## CN20006: RTG4 Family Important Changes

May 6, 2020

This document describes the following three changes to the RTG4 product family.

**Figure 1 • RTG4 Programming Options GUI**

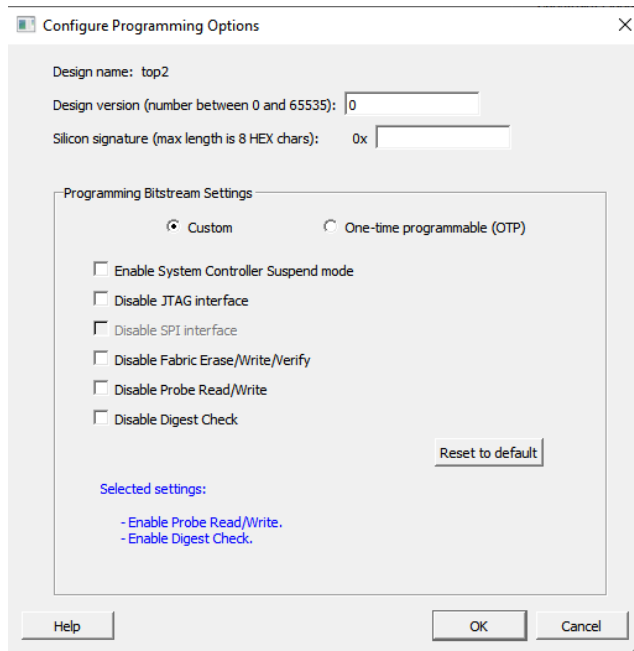
In Libero SoC v12.0 to v12.3, using the configuration tool to “Configure I/O States During JTAG Programming” can cause a loss of user programming settings selected via “Configure Programming Options”, “Configure Action/Procedure” for the “Run Programming Action” step, and “Generate Bitstream” options.

When operating an RTG4 device, if System Controller Suspend mode is selected, this issue could permanently prevent the device from exiting System Controller Suspend mode, and permanently lose the capability of reprogramming the device. We recommend upgrading to Libero SoC v12.4.

- For RTG4, this issue only occurs if running “Configure I/O States During JTAG Programming” in Graphical User Interface (GUI) mode.
- There is no issue if the “Configure I/O States During JTAG Programming” GUI is not used, no issues in Tcl scripted mode.

Do not program any further RTG4 devices with programming files (Libero SoC v12.0 to v12.3) using I/O states during programming GUI combined with the programming options listed above. Upgrade to Libero SoC v12.4, observe that all "Generate" and "Export" programming steps in the design flow will be invalidated, then re-run I/O States GUI and re-configure Programming/Bitstream options prior to Generating and Exporting new bitstreams.
